**RE: 62 Ellenwood Avenue**

I reviewed the drawings, and evaluated the site context. I am familiar with the site from previous reviews in the neighborhood. My comments and recommendations on the design are as follows:

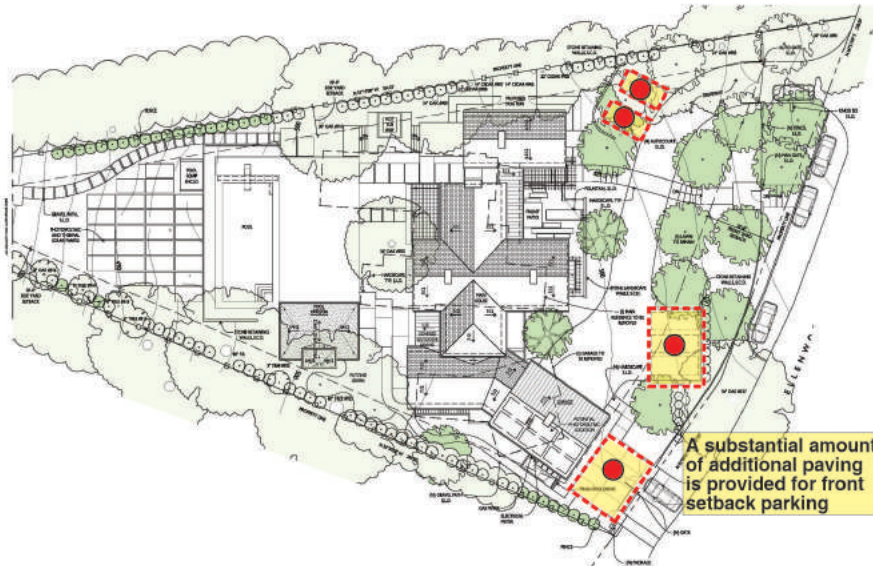
1. The additional landscaping in the front setback will be a welcome feature to integrate the home into the surrounding neighborhood, but the substantial additional paving proposed to provide at least six additional parking spaces seems out of character with the immediate neighborhood.

**Recommendation:** Remove some of the additional paving.

**Change in roof form and wall material seems arbitrary**

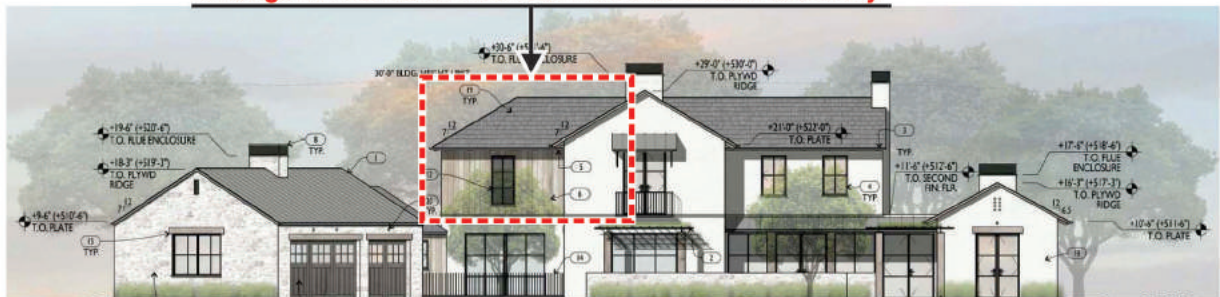
2. The change in roof form and wall materials on the second floor south wing of the house seems arbitrary, and an unwelcome change from the traditional forms and simplicity of the house style.

**Recommendation:** Match the roof form and wall material of the other second floor masses.

**Match roof form and wall material of other roofs**
